Blair Creek Stream Mitigation Project

Year 2 (2023) Monitoring Report FINAL

Response to DMS Comments (January 2, 2024) for DRAFT Monitoring Year 2 Report.
Blair Creek Stream Mitigation Project, Clay County
Hiwassee River Basin: 06020002
DMS Project #100047
DEQ Contract #7415

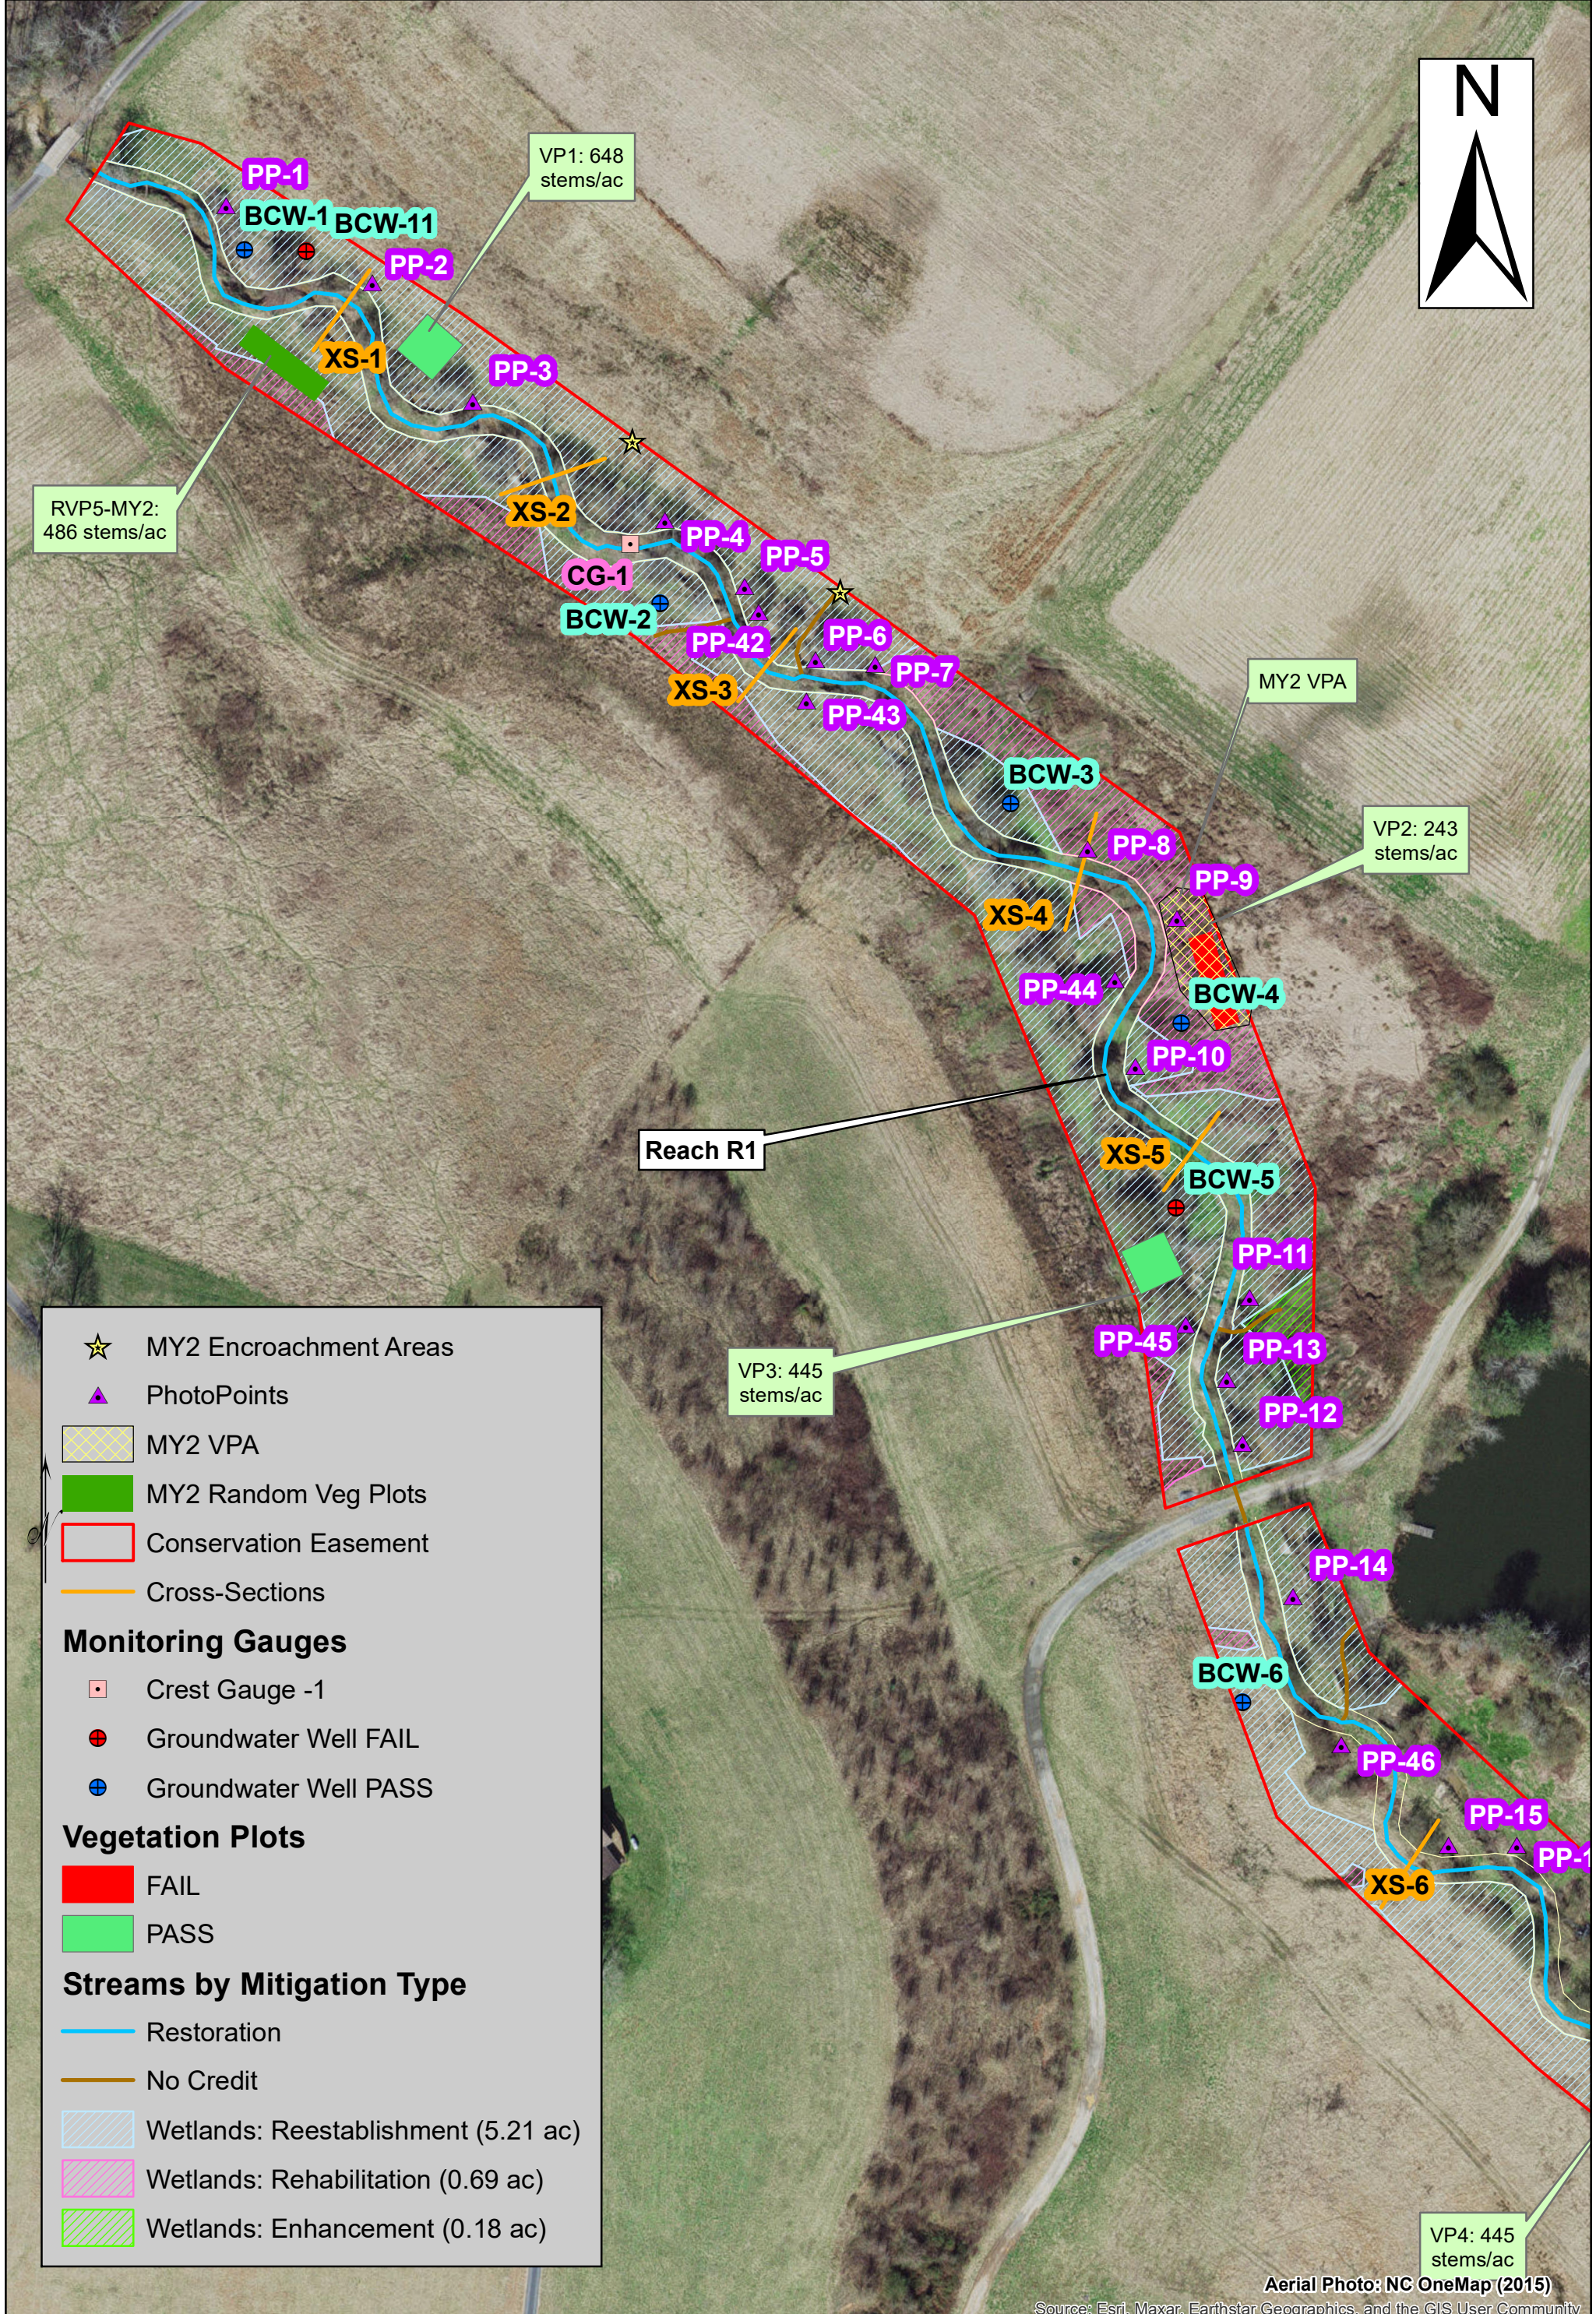
- SPA1 and SPA2 were repaired in July 2023. Please call out the location of these two repaired areas on the CCPV and update Table 2 to include the repair.

- Recommend revising ground water gauge labels on CCPV to be consistent with Table 11 and Figure 5. CCPV shows gauges as GW1 as opposed to BCW1 for Figure 5 and Table 11.

RESPONSE: These repair areas have been called out on the CCPV and added to Table 2 as requested.
- Invasive treatment occurred in summer 2023. Were any other species targeted other than cattails? Please update Table 2 to include the invasive treatment.

RESPONSE: The ground water gauge labels have been changed on the CCPV to be consistent.
- Table 5 indicates one structure is piping and bank erosion is present on Reach 1. This is not discussed in the report or shown on the CCPV. Please review and revise as necessary.

Permanent Cross-section 11

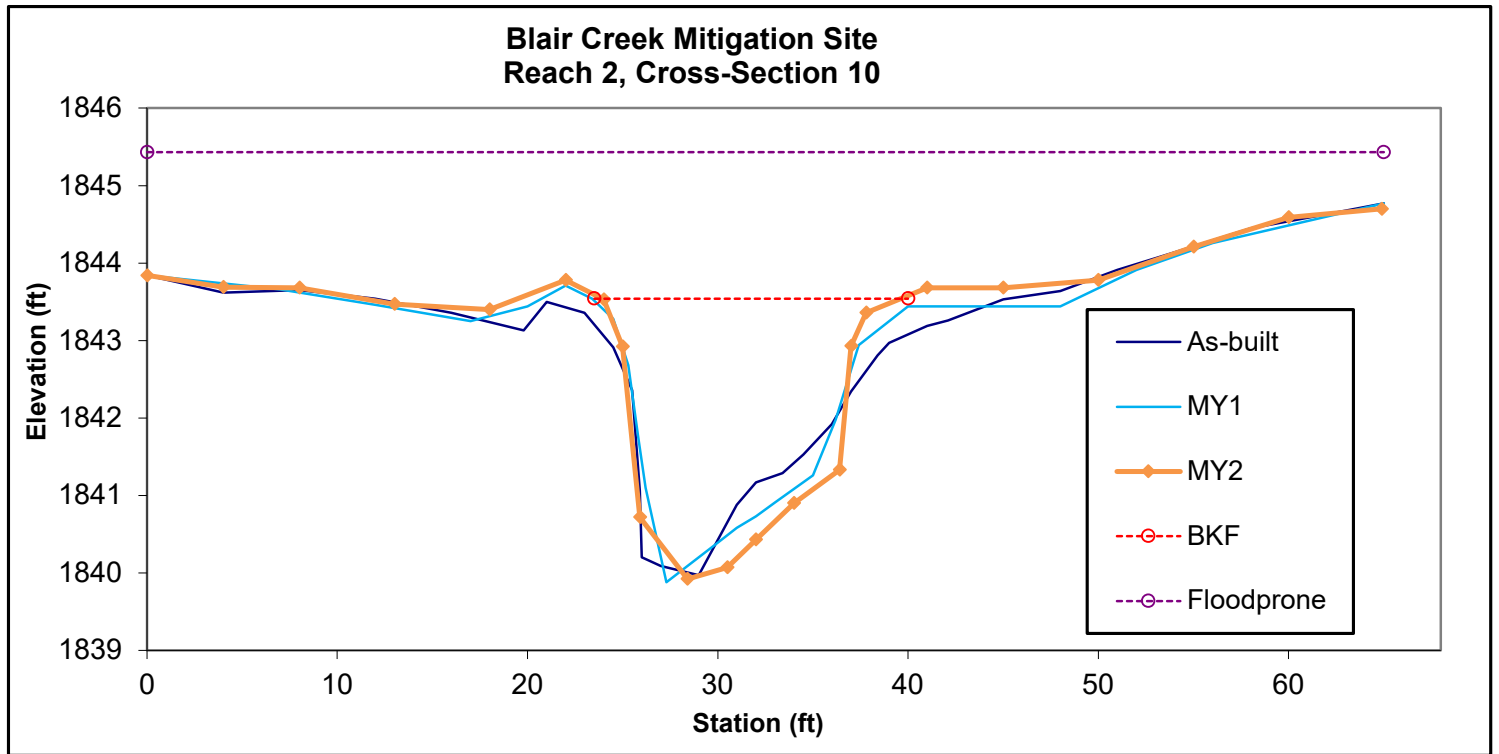
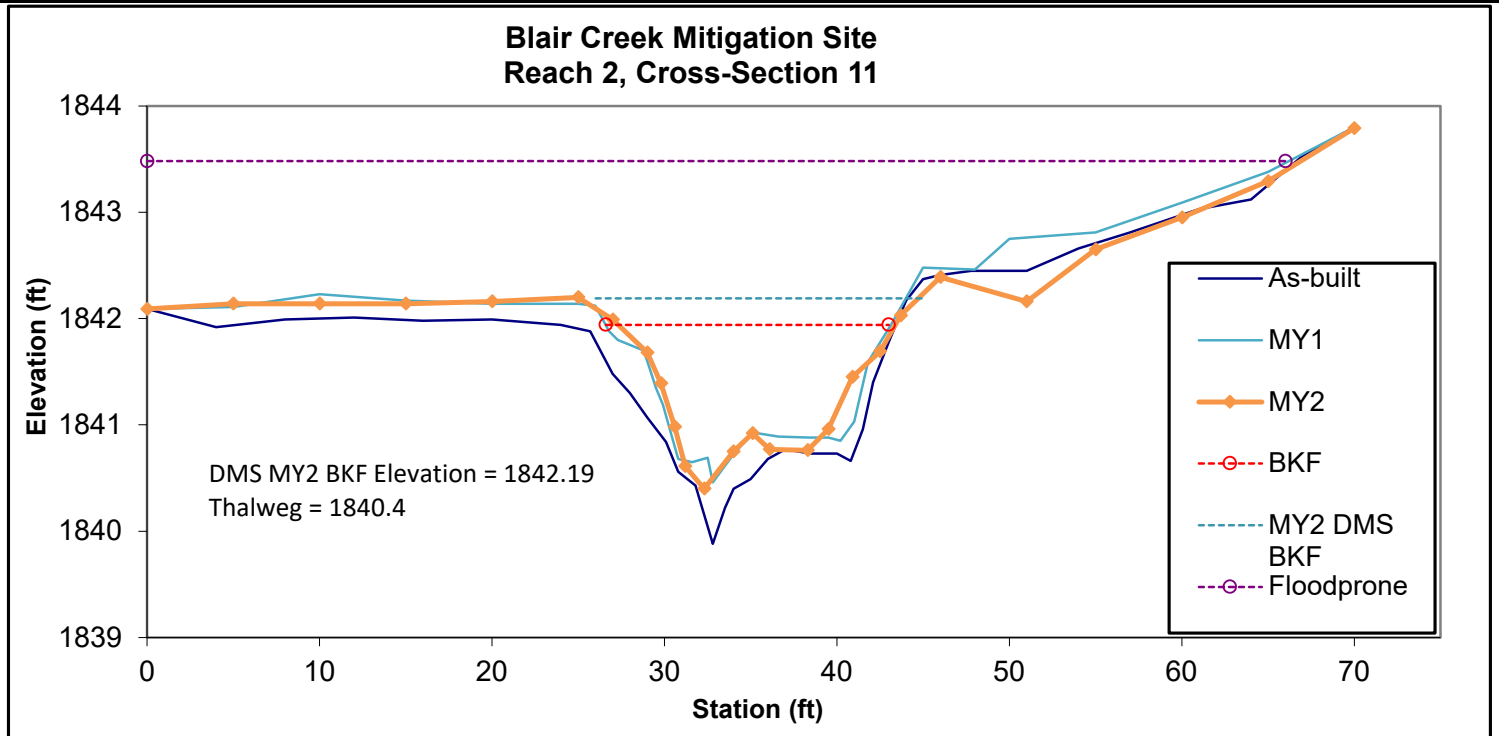
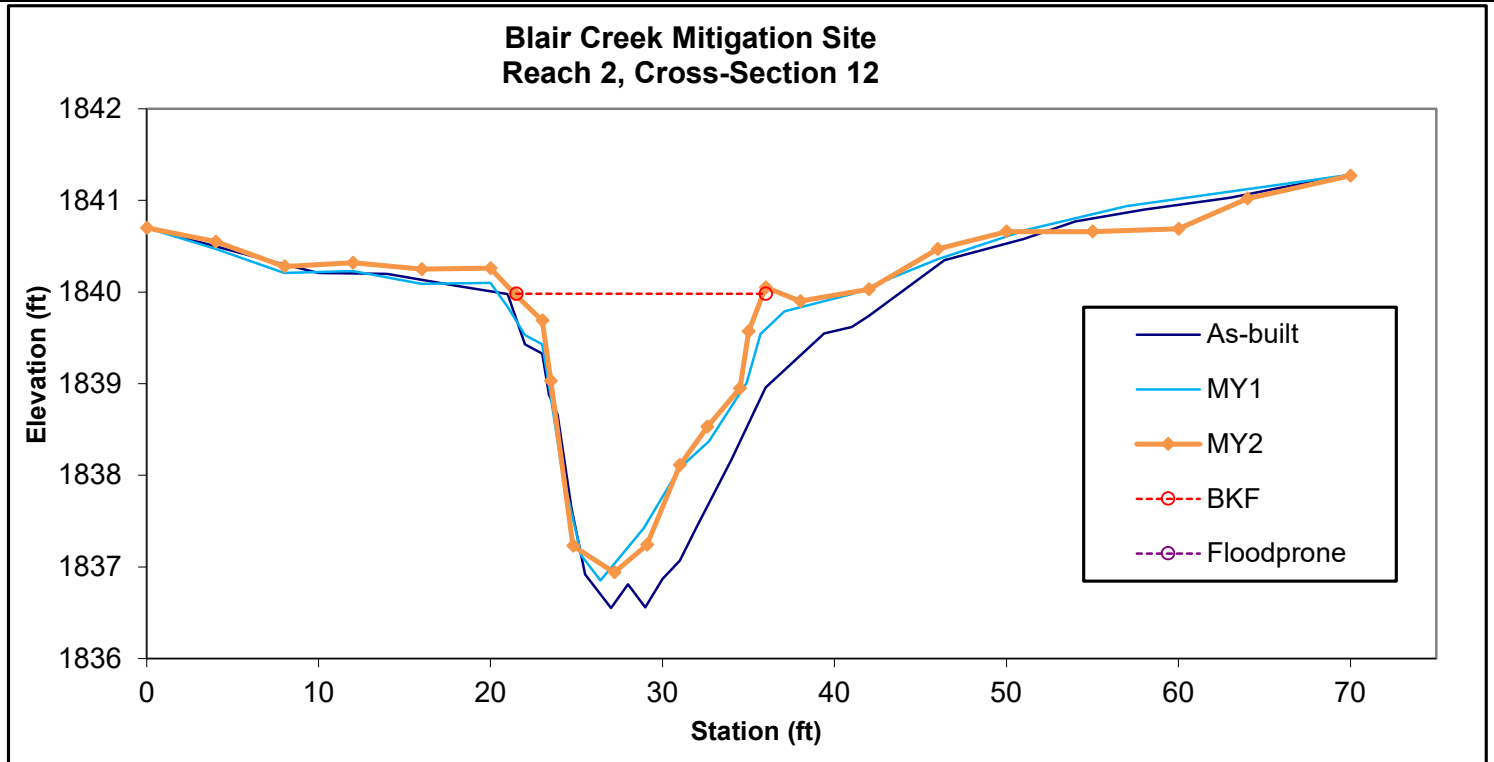
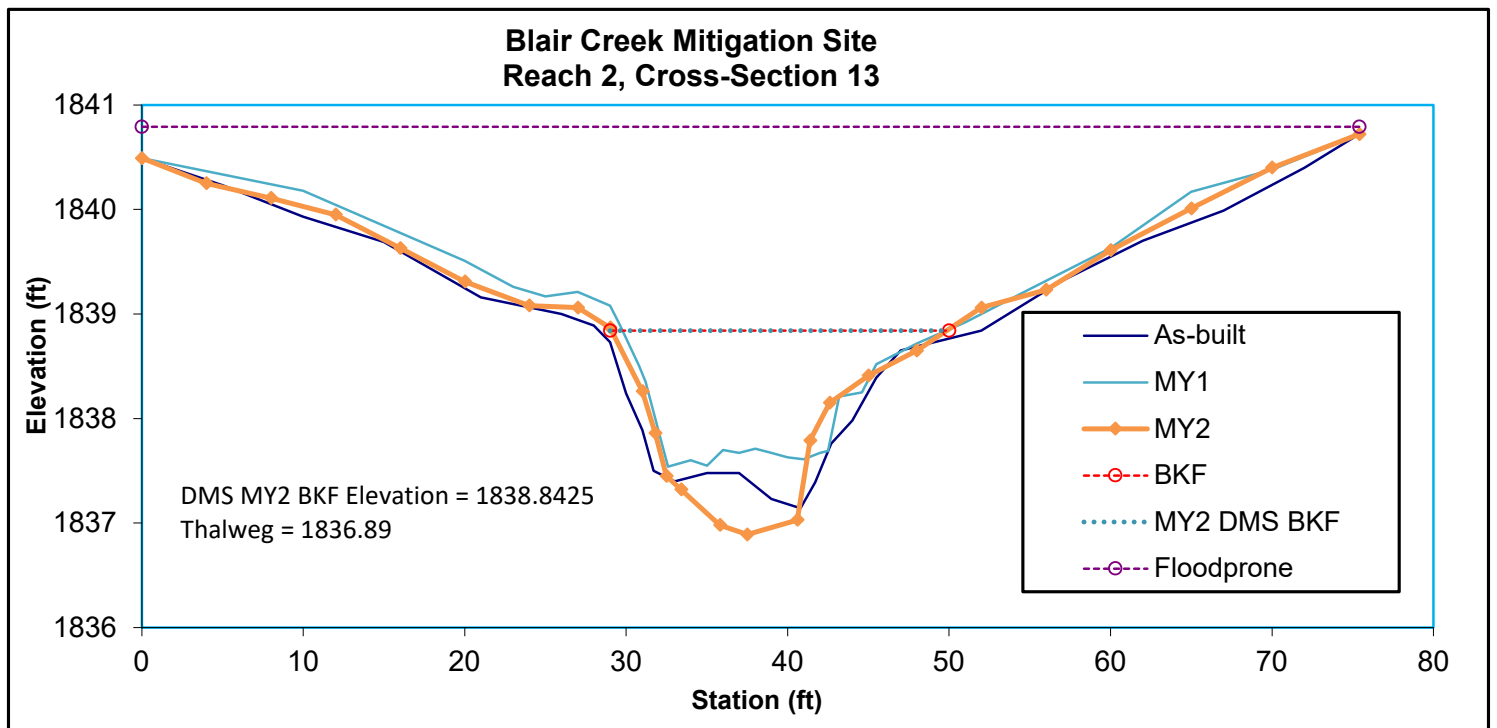
- IRT had concerns with changes noted in XS11, 12, 13 and 14. Recommend adding

additional discussion regarding changes since asbuilt and stream stability.

RESPONSE: A brief discussion of stream stability has been added to Section 1.4 Monitoring Results and Project Performance.

Figure 7. Observed Rainfall vs. Historical Average

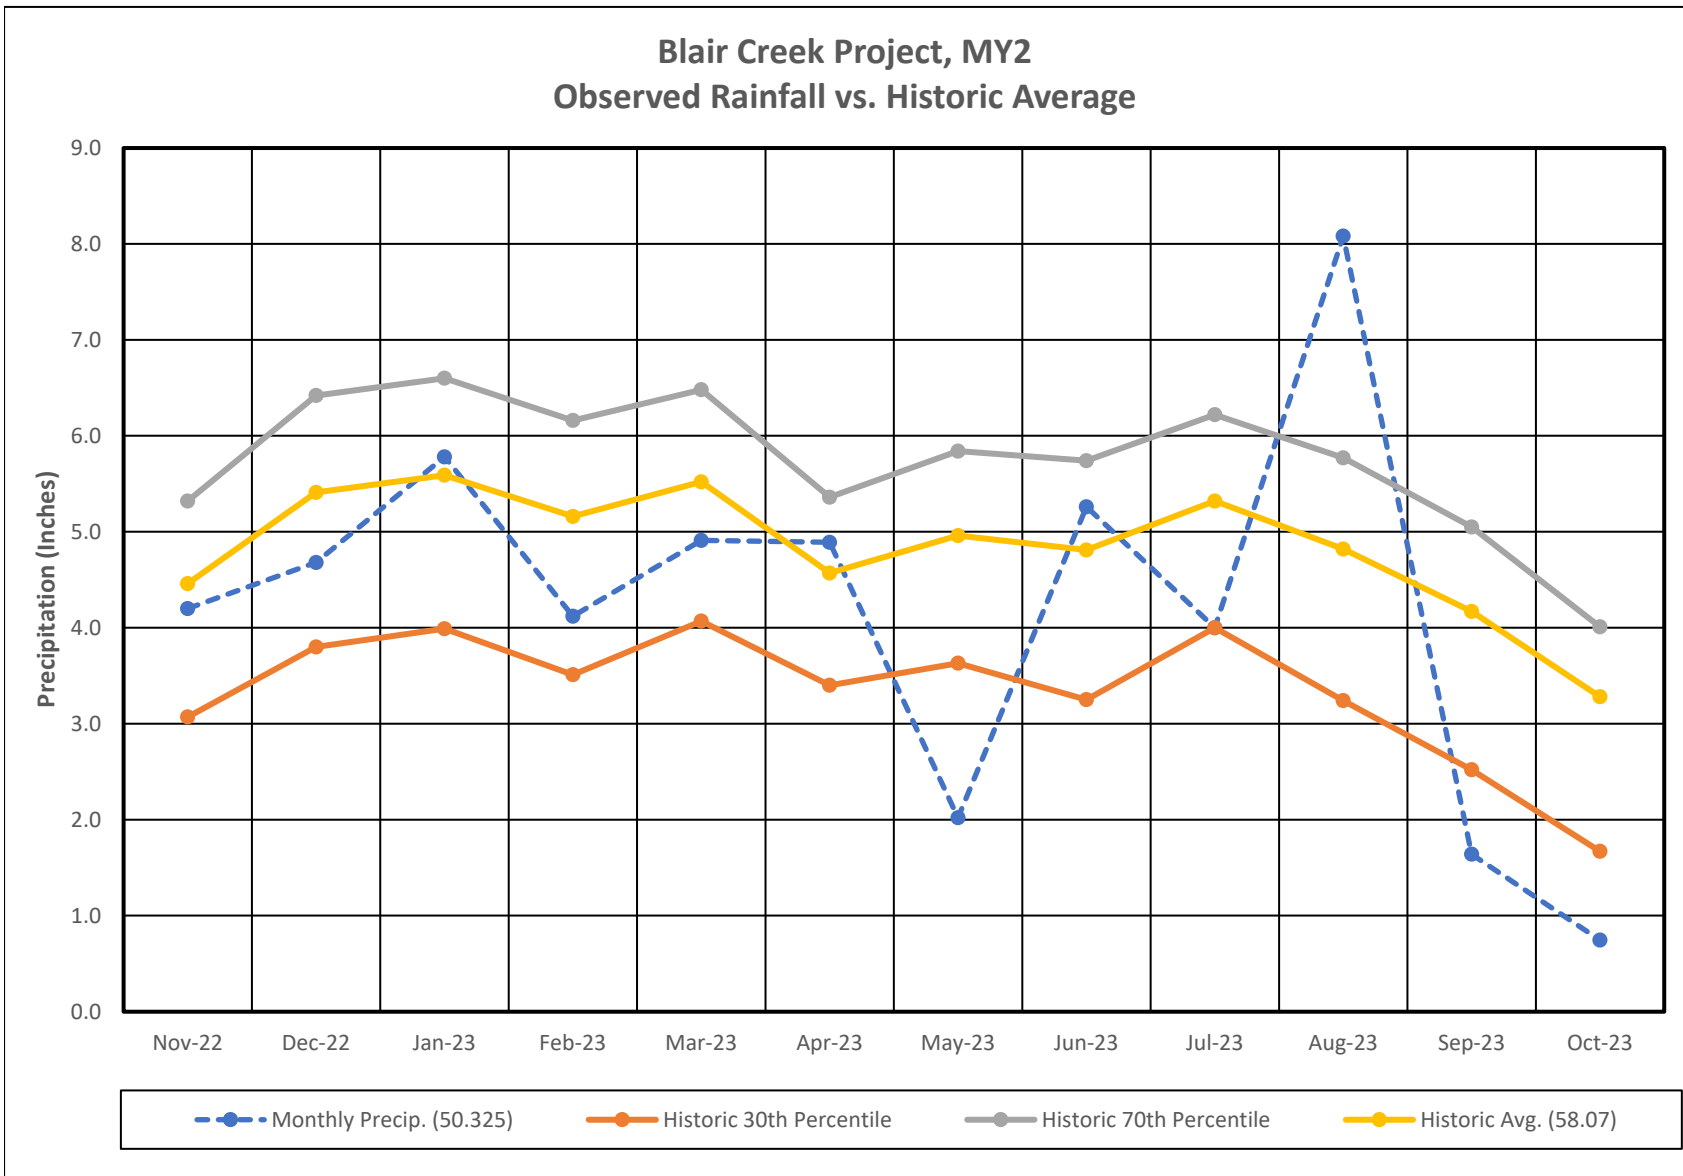
- There was discussion regarding how rain gauge data was collected for the site. Baker indicated that offsite gauge data was preferred due to onsite gauge malfunctions. Please include additional information regarding the NC Climate Office Weather Climate Database Legacy System that was used this year for observed project rainfall.

RESPONSE: A discussion of the NC Climate Office Weather Climate Database Legacy System, Multi-Sensor Precipitation Estimates (MPE) has been included in Section 1.5 Technical and Methodological Descriptions and a citation to support the efficacy of this system has been included in Section 1.6 References (Wooten 2014).
